SUBJECT: Forwards addl info re turbine bldg vent radiation monitors,
 in response to SER Confirmatory Item 26, identified by
 Meteorological & Effluent Treatment Sys Branch.

SHEARON HARRIS NUCLEAR POWER PLANT
UNIT NO. 1 - DOCKET NO. 50-400
TURBINE BUILDING VENT RADIATION MONITORS

Shearon Harris Nuclear Power Plant
SER Confirmatory Item 26
Turbine Building Vent Radiation Monitors

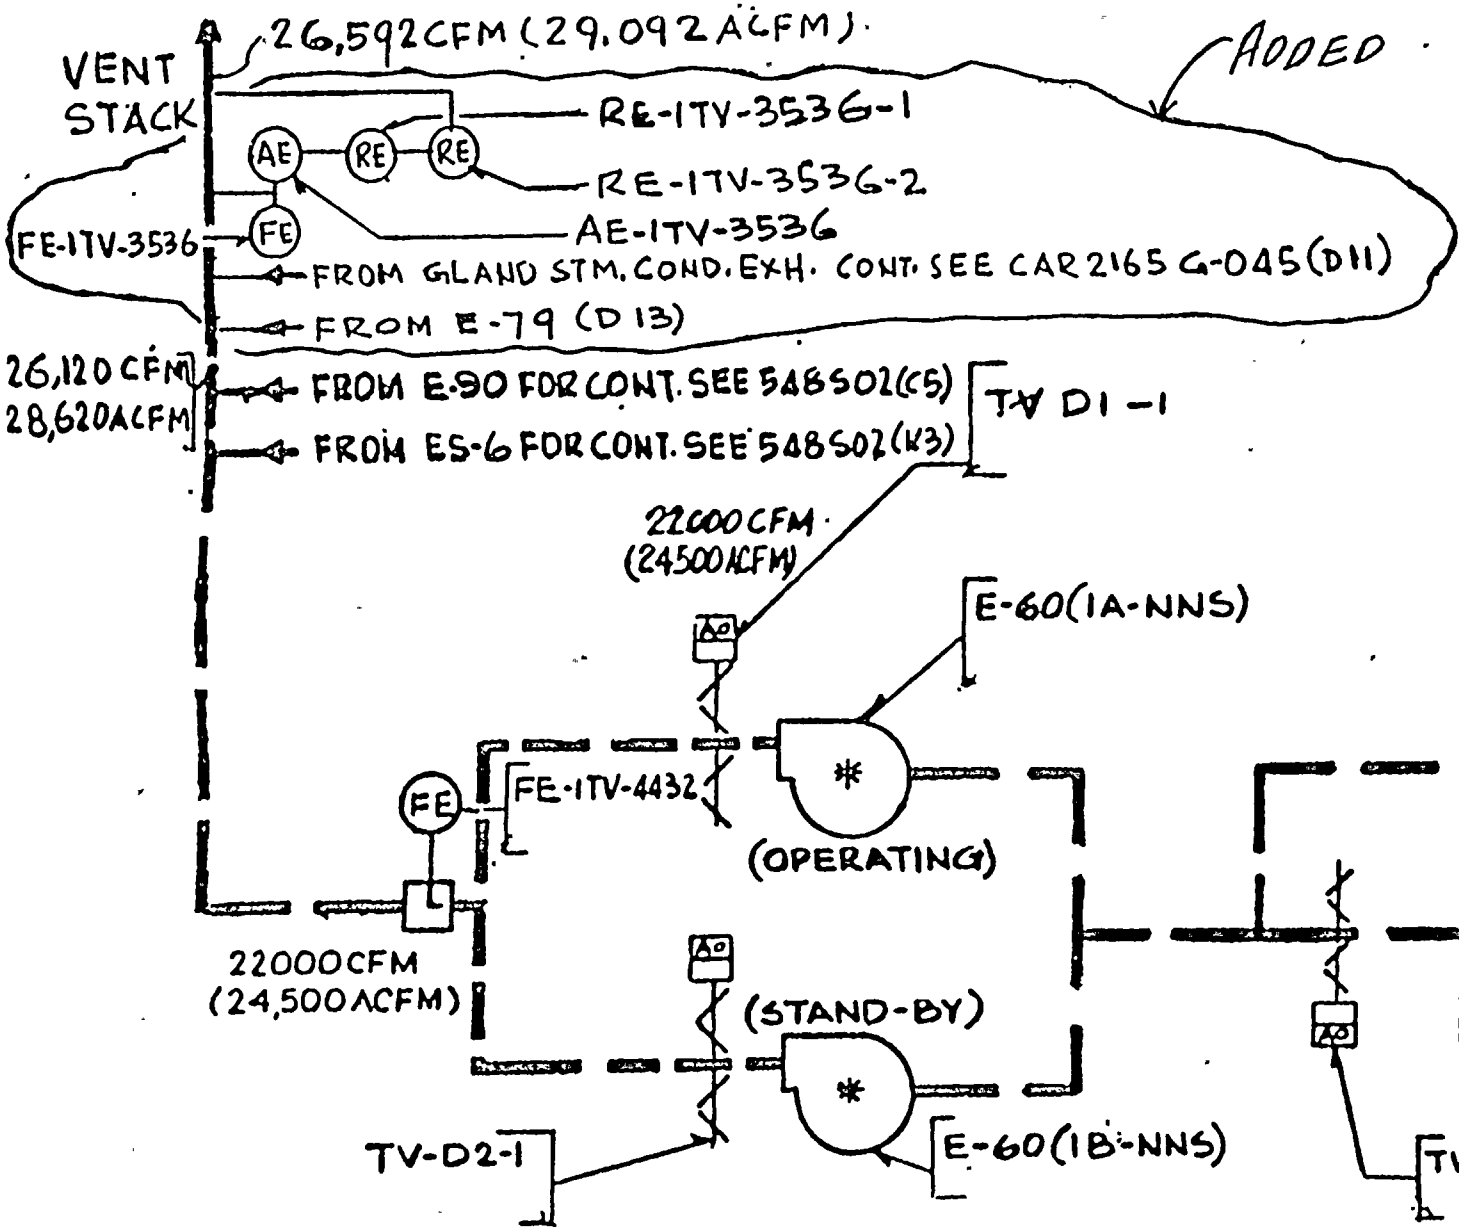
The applicant has committed to installing a wide-range noble gas monitor for withdrawing samples from the turbine building vent stack during normal operations and accidents. This monitor will also be provided with continuous sampling capability for radioactive particulates and iodine. The staff must confirm that the sampling by this monitor is conducted downstream of all potential radioactive sources. This is a confirmatory item.

The turbine building vent stack is monitored as shown on the attached portion of drawing CAR-2168-G-562. As noted on the revised area of the attachment, the monitor is located downstream of the various inputs including the gland steam condenser exhaust and the discharge from the condenser vacuum pump. FSAR Figure 9.4.4-1, along with FSAR Section 10.4.3 and 11.5.2, will be updated in a future amendment to reflect the revised information.
